RAVEN INDUSTRIES, INC.

SUBJECT: Service Bulletin No. 116

SERVICE BULLETIN 116

SUBJECT Superpressure Blower**APPLICABILITY** Raven Burner Models HP2C-101 to 164**PROBLEM** Change in dimension of fan hub affects position of upper face fan hub to motor shaft.**CORRECTIVE ACTION**

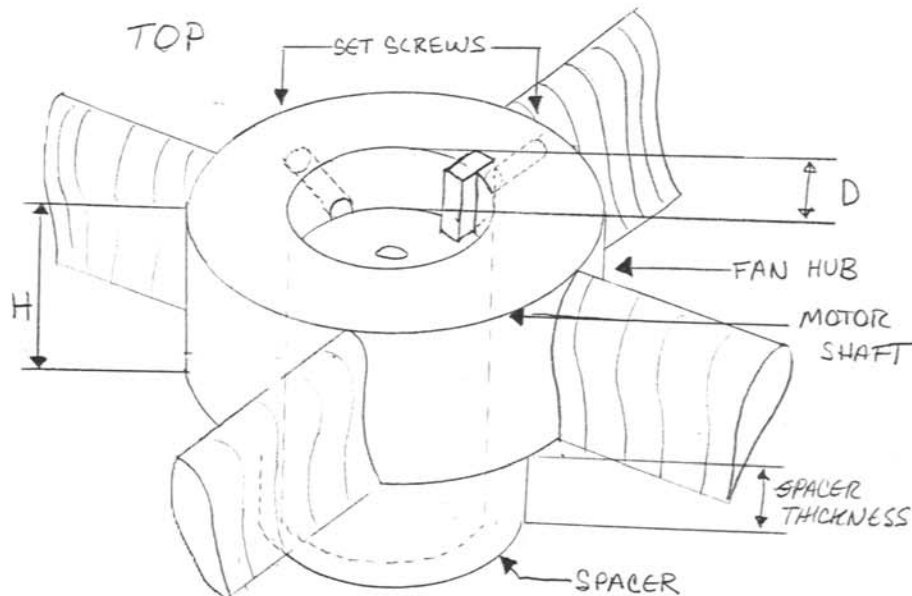
The supplier of the fan for this system has modified the fan hub dimensions slightly without any notification. The dimension change is pictured on the enclosed service bulletin as dimension "H" which was originally 1.45 inches. This change makes the thickness of the spacer very critical.

With the original 1.45 inch fan hub, the original spacer (.55 inch) brought the upper face of the fan hub flush or nearly flush with the motor shaft. The more recent fan hub with the .55 inch spacer brings the upper face as much as 3/8 inch above the motor shaft end. Consequently, it is possible that the hub set screws will only contact partially with the motor shaft end key. This means the fan could come loose over a period of time.

1. Remove blower assembly from burner.
2. Remove 10 cap screws which retain upper screen on top side of blower. Remove screen.
3. Using above illustration as a guide, measure distance D, shaft depth. If this distance is greater than 3/16 inch, proceed to step 5.
4. If distance D is 3/16 inch or less, the fan hub distance H is nominally 1.45 inches which is acceptable. Fill out the blower card and check the box marked "Spacer not required." Replace the blower screen and snug the cap screws. Please return the card to Raven.
5. If distance D is greater than 3/16 inch, fill out the blower card and check the box marked "Spacer required." If rapid service is needed, call Raven and request a new spacer. It

6. Remove fan and hub. This may be done first by loosening two set screws several turns and then using a puller, such as a gear puller, steering wheel puller or another type.
7. Remove the old spacer and replace with new spacer. Replace fan, hub and key. Tap hub gently with a hammer to seat the assembly onto the spacer. (Check to be sure the fan blades do not hit the motor mount bolt-heads during rotation.) Tap key gently into place so it is flush with the face of the hub. Tighten set screws and replace upper screen and cap screws.
8. Please return the "Work Performed" card to Raven with the appropriate information.
